REQUEST FOR INFORMATION DATE: April 26, 2017 NO.: RFI-521

Project Name: 15051-Webster University Interdisciplinary Science Building Project No.: 15051

Subject: Riser Cables at Data Room Ceilings

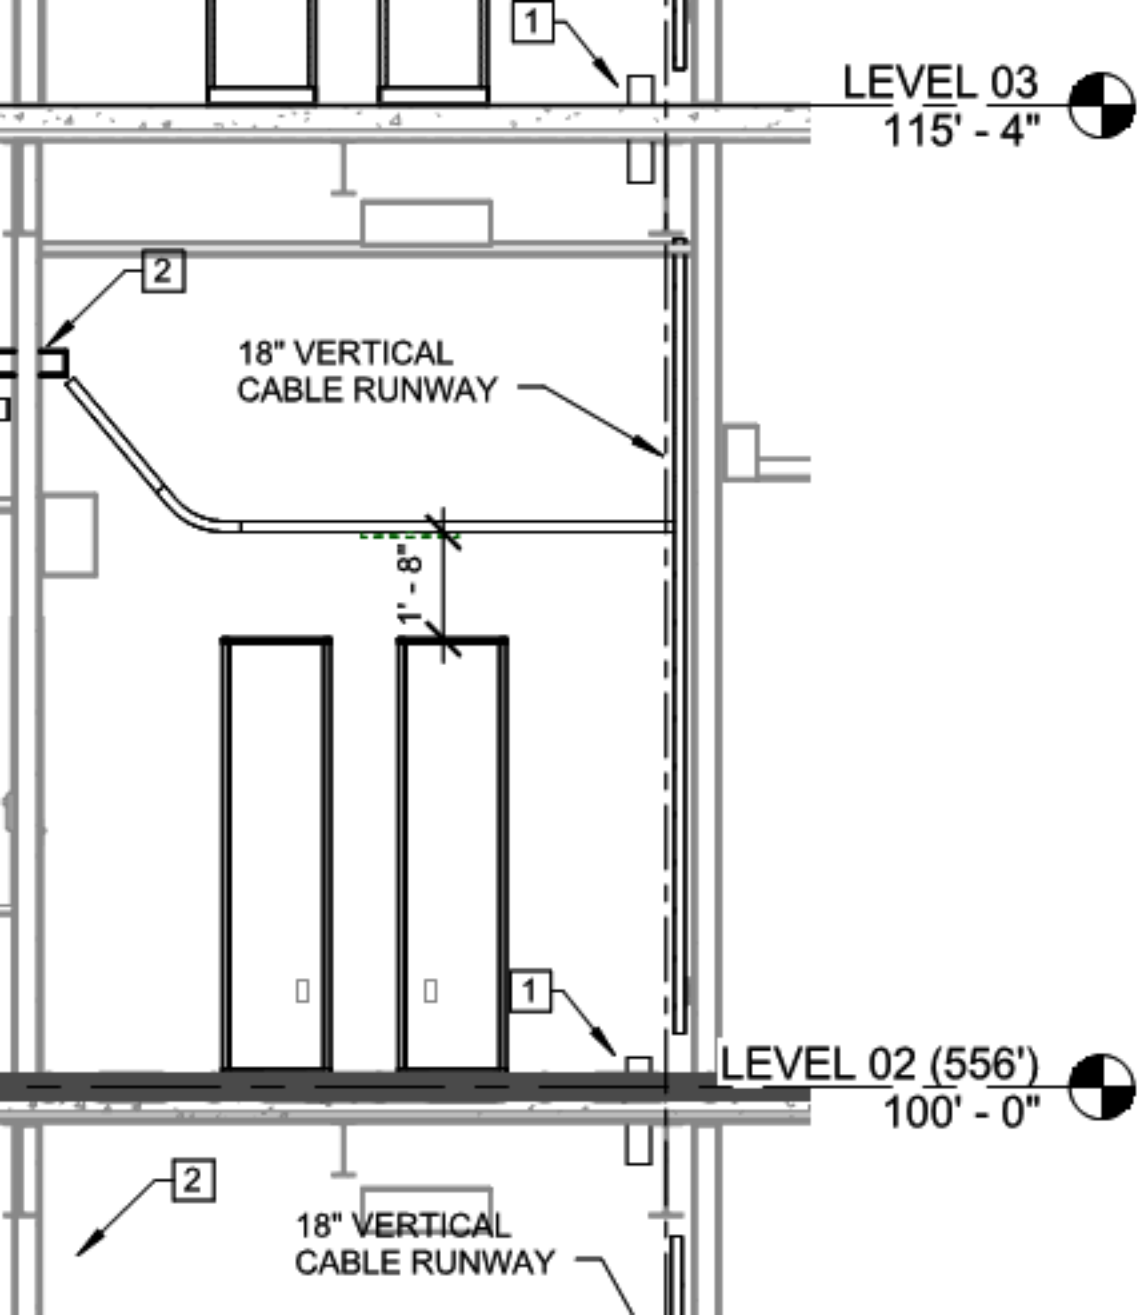
Room 100B does not have a drop ceiling, however 200B, 300B, and 400B do per the RCP. Please identify the design intent for bringing cables down from ceiling.

1 foot gap
between the
EZ Path
sleeves and
the drop
ceiling

Contractor shall provide opening in ceiling tile for cable penetrations. Utilize a hole saw or cut a slot large enough for cable penetrations but no larger than necessary for cable penetrations at each Data Room ceiling.
